DATE: June 26, 2023

ADDENDUM NO. 28

PROJECT NO. DGS C-0211-0005 PHASE 005
PROJECT TITLE - PA State Police Academy - Core Bldgs, BESO & Sitework
PROFESSIONAL:
SOM
7 World Trade Center
New York, NY, 10007

1 GENERATOR TOP VIEW
SCALE: N.T.S.

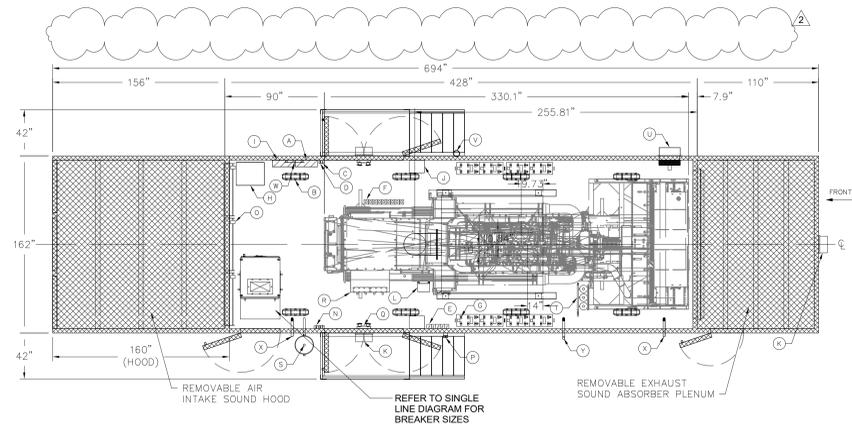
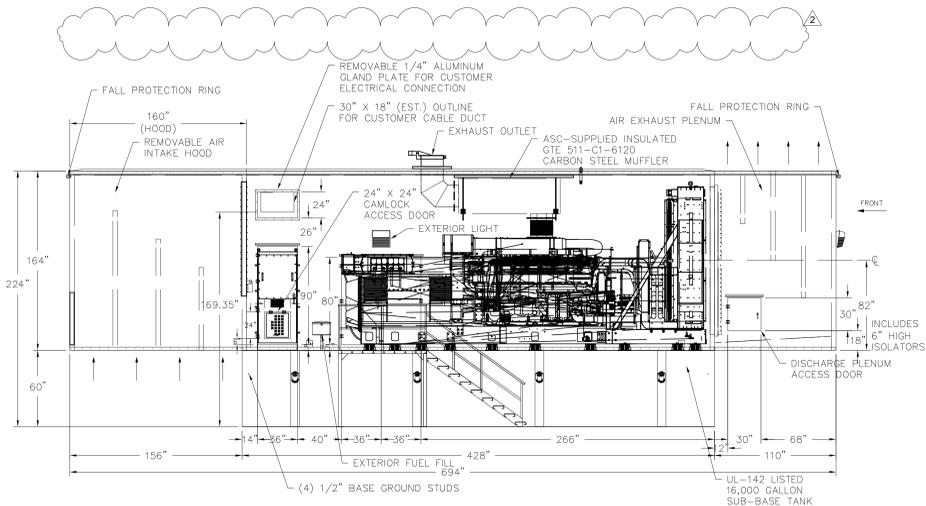
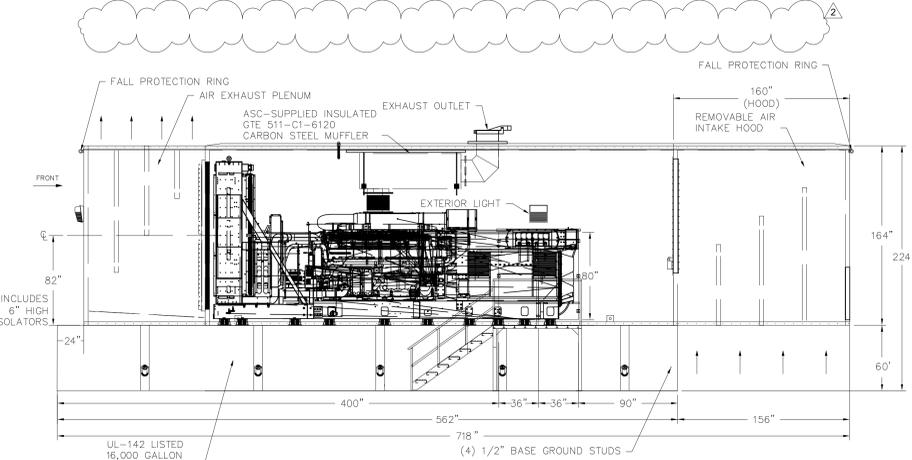
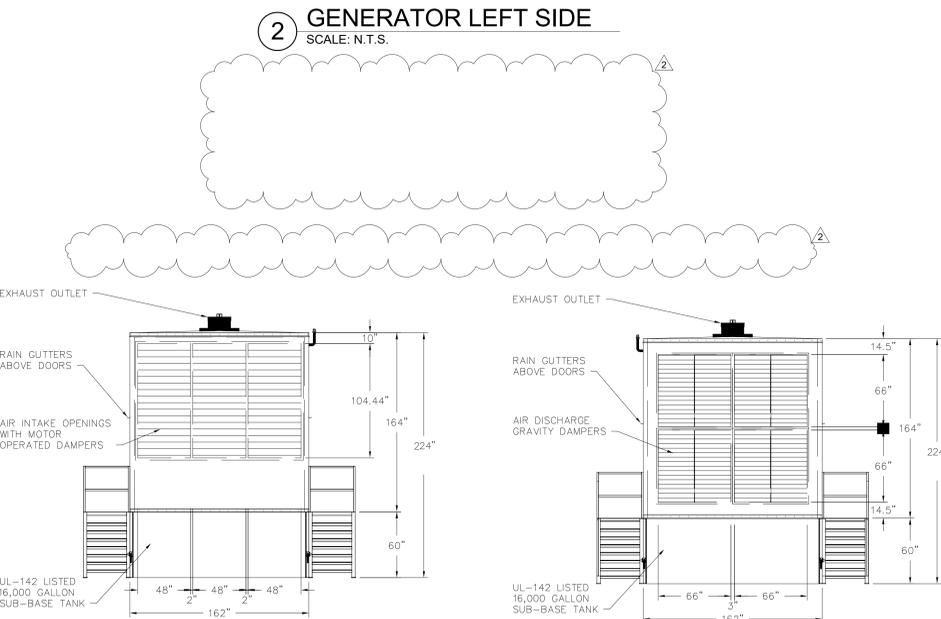
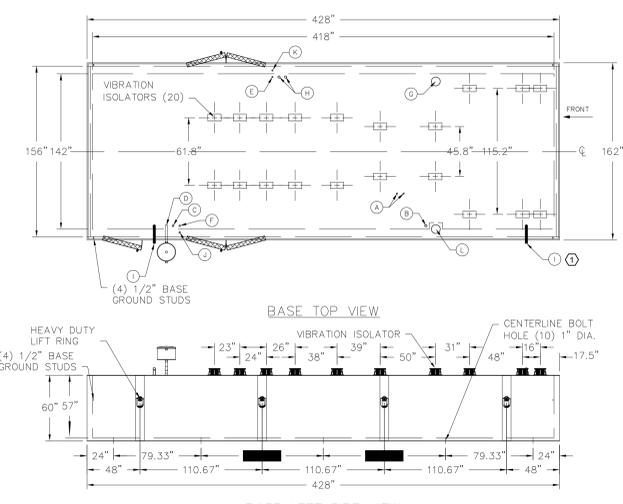
- Response: Refer to revised spec section 263213 and drawing MAQ-E-505 as issued in Addendum 28, modified to show belly tank only.
- Question 3: Spec section 263213, 2.2 list generator MAQ at 2800KW. Drawing MAQ-E-501 calls out 3125KW. Drawing MAQ-E-505 calls out a 3250KW. Please clarify the generator size.

- Response: Refer to revised spec section 263213, drawing MAQ-E-501, and MAQ-E-505 as issued in Addendum 28 clarifying generator size.
- Question 4: Spec section 263213, 2.7 calls out 81.4dba at 23'. Drawing MAQ-E-505 calls out 75dba, and 80dba. Please advise free field dbA level at 23'.

- Question 7: Drawing MAQ-E-505 calls out a 6,000gallon base tank and a 10,000 gallon day tank. This is contradictory. If the 6,000 gallon tank is a subbase tank, then it would have floats, return pump, and controls and be considered the day tank. The 10,000 gallon tank would be the main tank supplying the 6000gallon belly day. The same drawing also calls out a 15,917 gallon base tank. What fuel tank configuration is requested for this genset?

- Response: Refer to revised spec section 263213 and drawing MAQ-E-505 as issued in Addendum 28, modified to show belly tank only.
- Question 2: Since specs on the main tank and fuel polishing system are located in spec section 231113, its assumed that these are not being provided by the generator manufacture.

- Response: Refer to revised spec section 263213 and MAQ-E-505 as issued in Addendum 28 clarifying dbA levels.
- Question 5: Drawing BSO-E-100 calls out a 750KW genset. Spec section 263213 does not list a 750KW genset. Genset elevation shows a generator without a base tank. How is this genset fueled?

- Response: Refer to revised drawing MAQ-E-505 as issued in Addendum 28 clarifying belly tank size.
- Question 8: the lighting symbol legend seems to be incomplete and lacking descriptions. Please clarify and provide more description for lighting symbols on drawing GEN-E-001
